# **Final Market Rule Change Report**

**Title: Outage Notification to the IMO**

Ref: RC\_2007\_16

Date: 24 September 2007

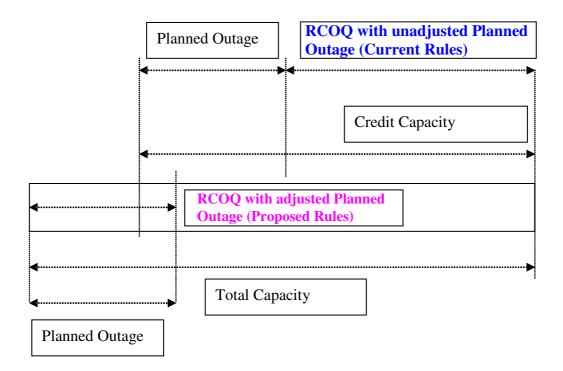
System Management submitted that currently, the RCOQ is reduced from the Reserve Capacity Credits awarded to a facility by a Planned Outage. Without adjusting the Planned Outage amount, the facility's RCOQ will be reduced from the capacity credits to a level that would result in a capacity below that which the facility is capable of providing. It is therefore appropriate to adjust the Planed Outage to take into account the excess capacity before adjusting the facility's RCOQ.

The adjusted Planned Outage amount would therefore reduce the facility RCOQ to the level marked as 'Proposed Rules' in the diagram below. This is the level the facility is capable of performing.
